**Zoning Commission Case No. 05-39
PUD for St Martins Apartments
116 T Street, NE (Square 3531 Lots 114 and 115)
Archdiocese of Washington and Catholic Charities, applicant
Eckington Citizens for Responsible Development,
Final Submission 26 February 2007**

Zoning Commission Case No. 05-39
PUD for St. Martin's Apartments
116 T Street, N. E. (Square 3531, Lot 114 and 115)
Archdiocese of Washington & Catholic Charities
27 January 2007

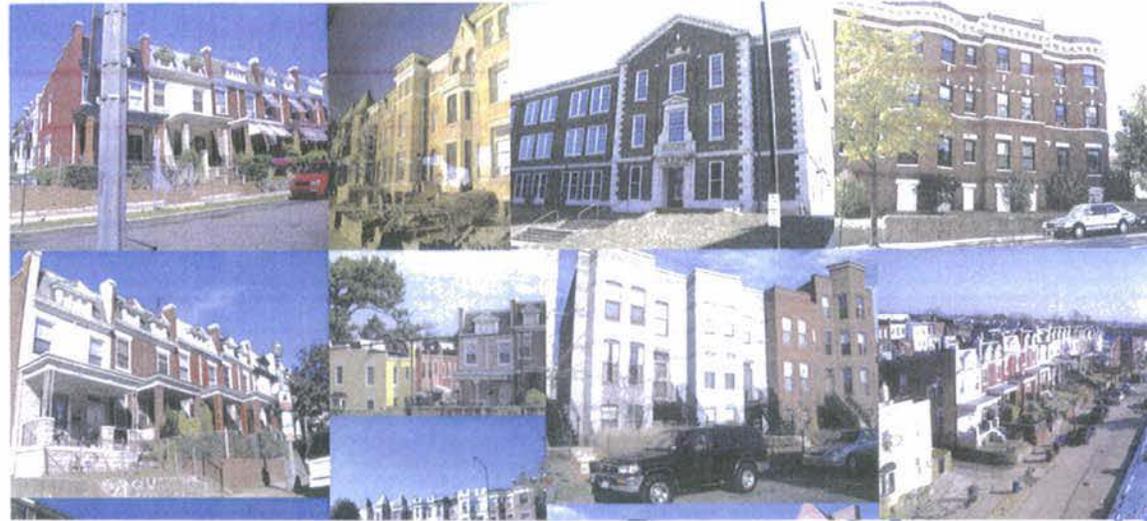
The two historic structures on the site -- both designed by a well-regarded Washington ecclesiastical architect -- as well as the houses in the surrounding neighborhood -- many also by master architects -- are far more restrained in design and in the use of materials, than that proposed for the apartment building. The project, therefore, would not improve the district.

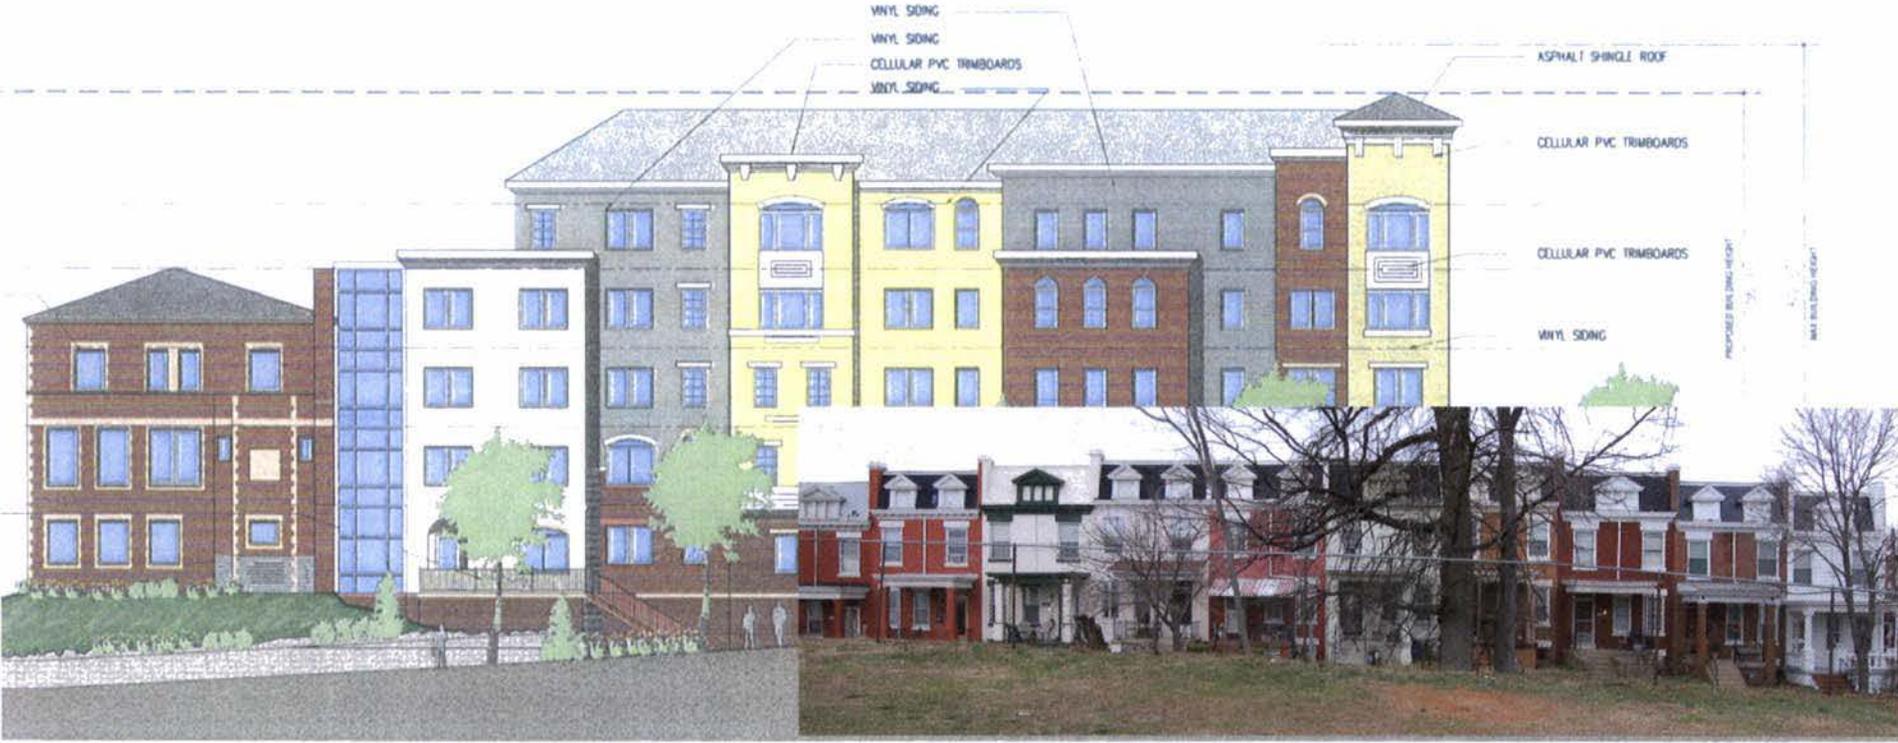
The architects have indicated that these were these images are the precedents for the proposed building. Unfortunately, what they have done is take an element or motif from almost every building in the vicinity and incorporated them into this single project. This is the variety of design and materials that one might find in a commercial district, but it's incompatible in this context.

The convent appears to the left of the elevational drawing, clearly indicating that the apartment building would tower over it and also clearly demonstrating that the frenetic design of the proposed building is inconsistent with the restraint of the convent.

Because the design of the project would be incompatible with its context, it could not possibly be considered to be an improvement to the neighborhood.

ARCHITECTURAL ELEVATION

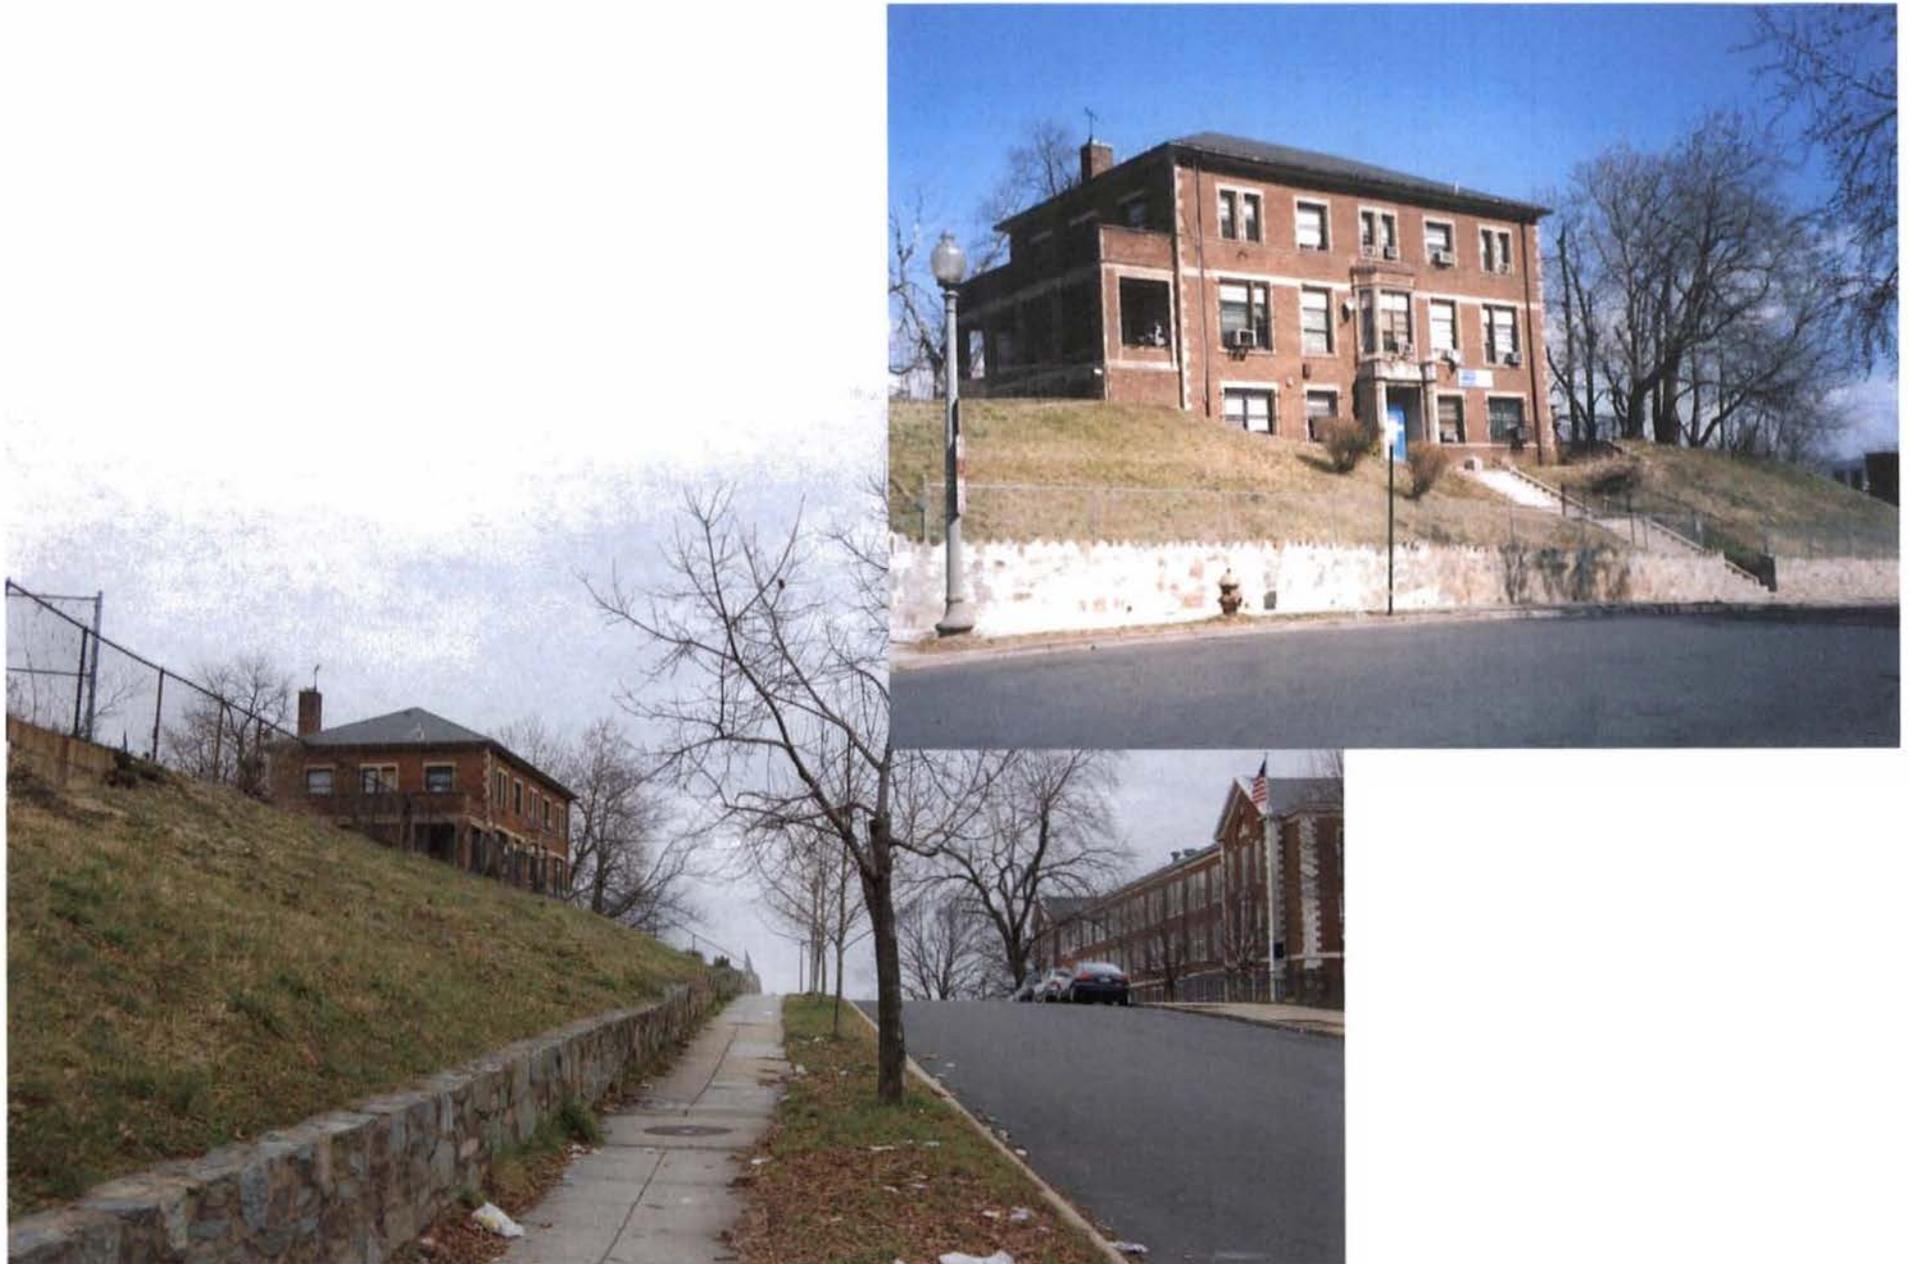
The proposed building would be incompatible in scale with the proximate houses and, therefore, not an improvement to the neighborhood. Furthermore, it in no way respects the established pattern of residential development in the area.

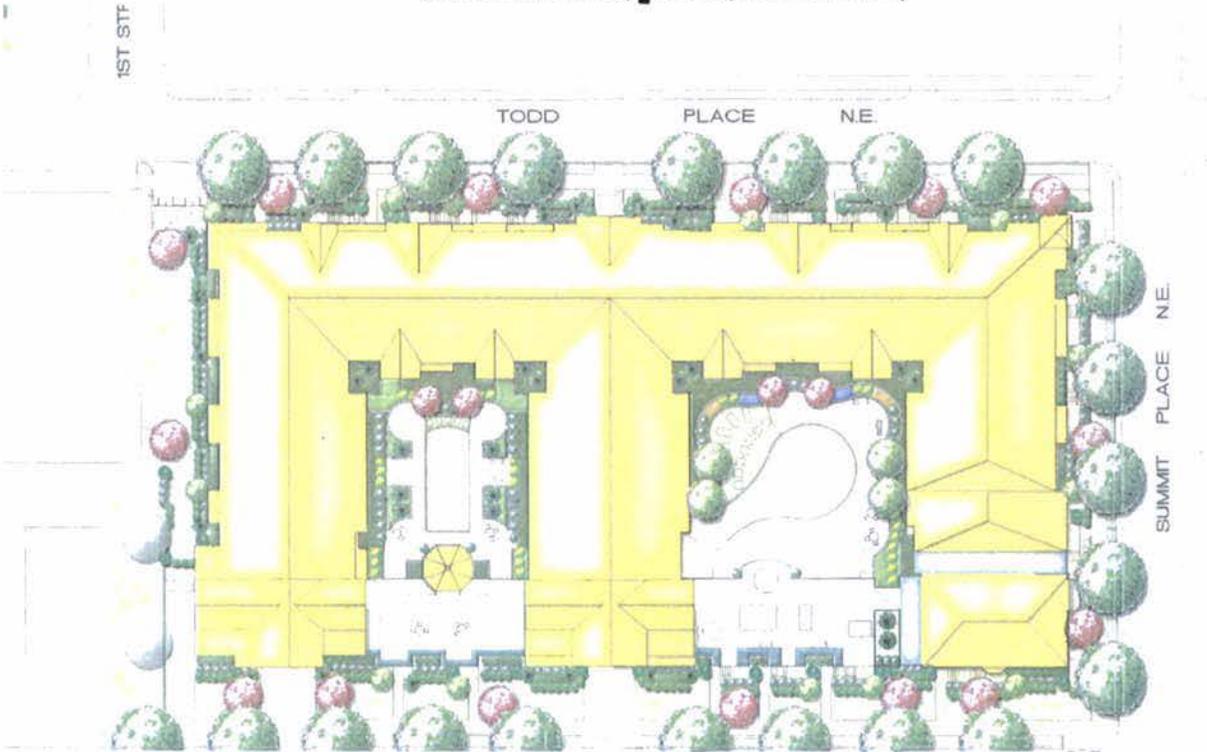
The steep slopes that characterize the site with significant changes in grade -- approximately twenty feet, between the street frontages and the highest elevation near the center of the site -- would be demolished. The hill, one of the highest in Northeast Washington, is a character-defining feature of the neighborhood as well as of the city as whole, especially as one enters the city from the northeast. Furthermore, while residents of the area are not entitled to physical access to this private property, they do have visual access to the Washington Monument, National Cathedral, and the city-scape. This would no longer be the case if the project were allowed to go forward as currently designed.

This could not be considered to be 1) an acceptable historic preservation solution, nor 2) an instance of respecting the physical character of the district, nor 3) providing visual orientation, nor 4) an environmental benefit.

Removal of the hill is an extreme measure and unnecessary in order to provide affordable housing and, further, should not be done in the absence of an environmental impact statement.

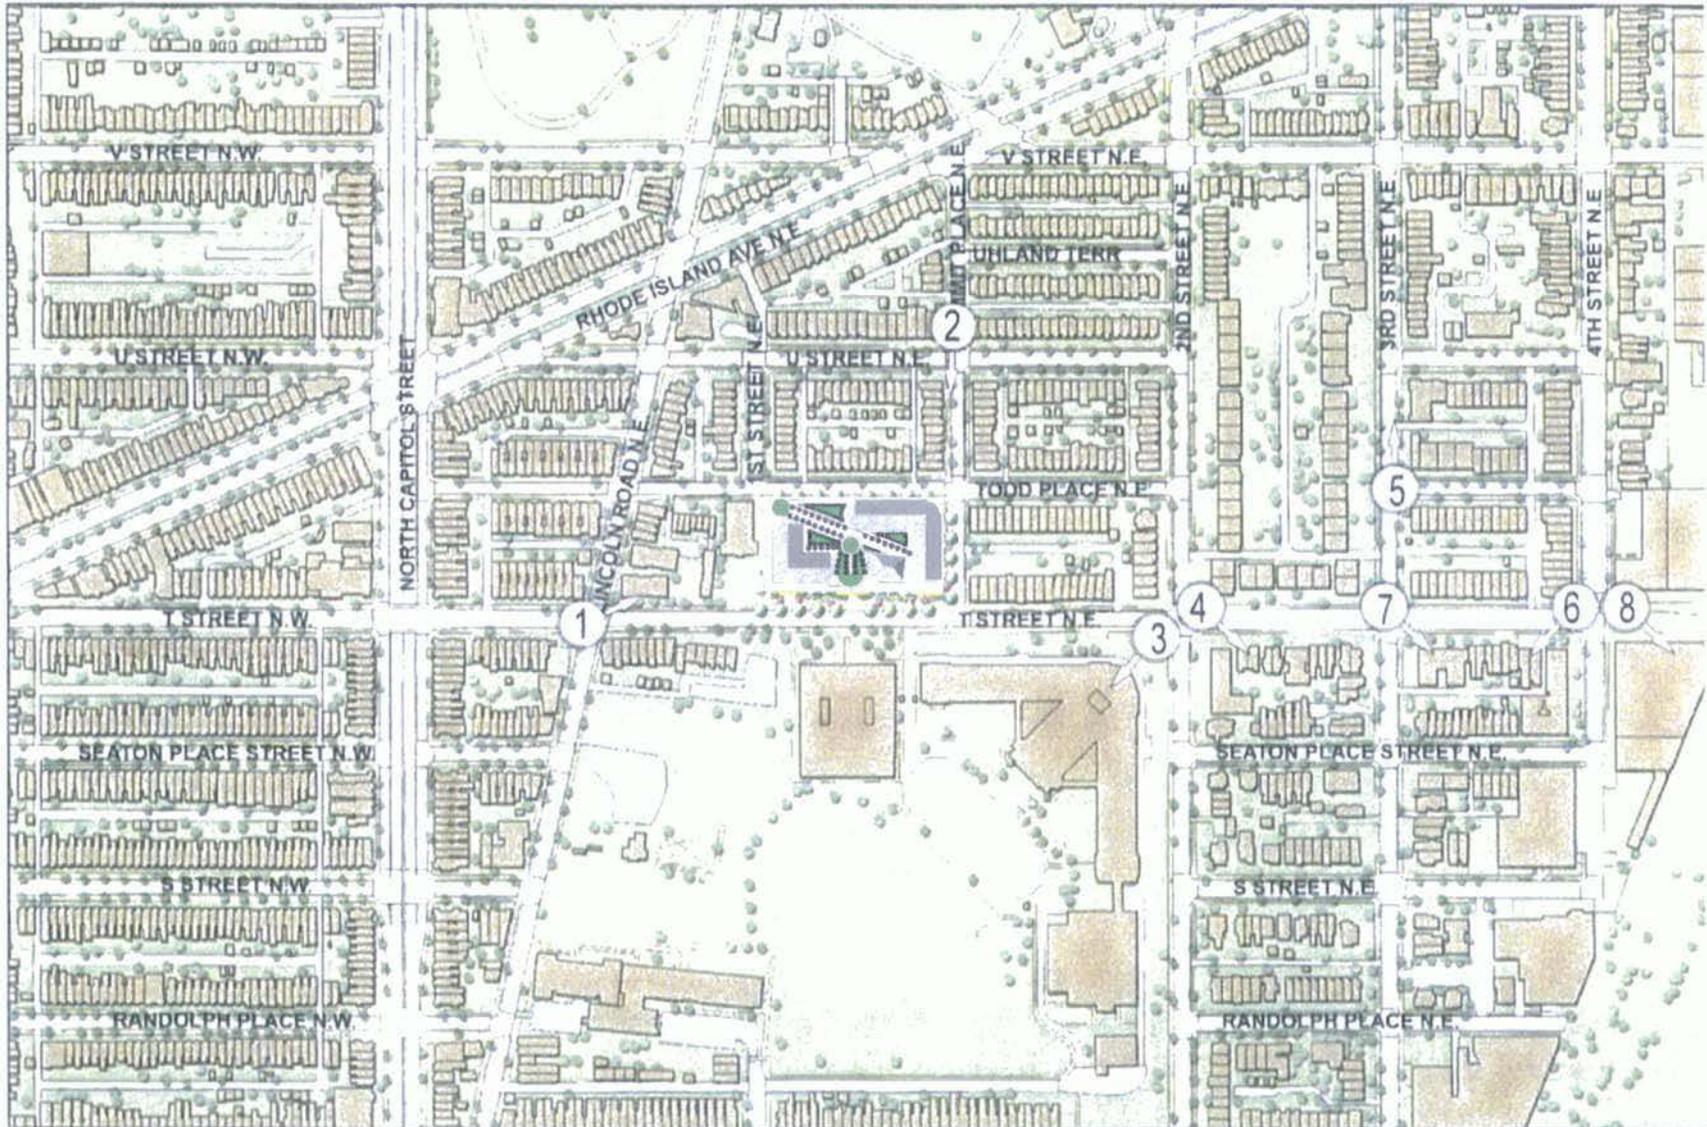
The proposed apartment building would be an impenetrable fortress that that would not permit social interaction with the neighbors; an unfortunate oversight in a neighborhood that provides, with its front-porch row houses, a superb example of architecture that effectively promotes community interchange. The project, therefore, does not respond to social responsibility for the surrounding residents nor would it produce a favorable impact.
